January 19, 2000

John T. Yankovich  
Senior Engineer  
Sealed Source Safety Section  
Division of Industrial and Medical Nuclear Safety  
Office of Nuclear Materials Safety and Safeguard  
United States Nuclear Regulatory Commission  
Mail Stop: T-8F-5  
2 White Flint North  
11545 Rockville Pike  
Rockville, MD  
20555

Your letter dated November 23, 1999 with comments pertaining to our registration request for the device, TheraSphere, was received by fax on December 15, 1999 and by mail on December 17, 1999.

Lead Pot/Lucite Shield Label

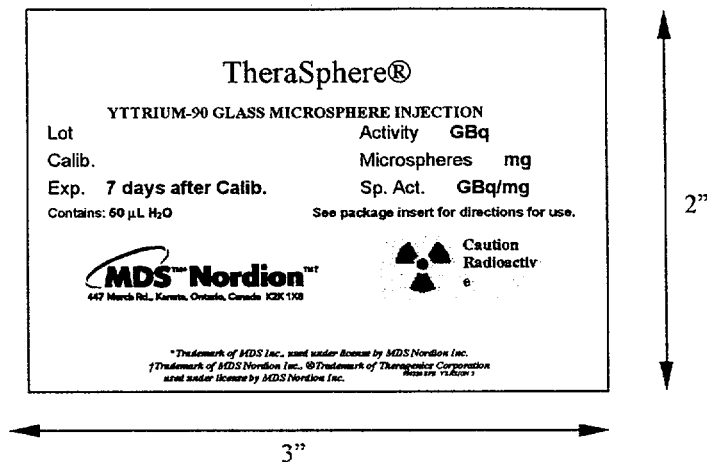
- a. the material, thickness and adhesive characteristics of the label which you intend to use on the lead-pot/lucite-shield (page 7 of the application);

- b. the handling and storing instructions as required by 10 CFR 32.74 (a)(2)(viii);

- c. how you will designate the activity level as required by 10 CFR 32.74 (a)(3).

4. Specify if you use serial numbers to identify each TheraSphere dose. If yes, please indicate where the serial number is located and how durable the identification is. If no, describe why individual dose identification is not needed.

The laser label materials for the lead pot and lucite shield are the same. The label face materials is a 60# matte litho, 3.4 mils thick with a superior smooth surface for laser printing. The adhesive is E117, a water based, acrylic and permanent with high shear strength and good initial tack. The liner is B85, a hygroscopically stable coated paper that has excellent "flatness" properties as required for laser printers.

The statement on the product label "See package insert for directions for use" will be updated to say "See package insert for directions for use, handling and storage"

The terminology "Calibration", on the lucite and lead pot label, will be changed to "Date of Assay" to comply with the requirements of 10 CFR 32.74 (a) (3).

As shown on **Page 7, Labelling** of the original submission the lot number of the product is identified as "lot" on the product label. A copy of this page has been appended. (Attachment 10)
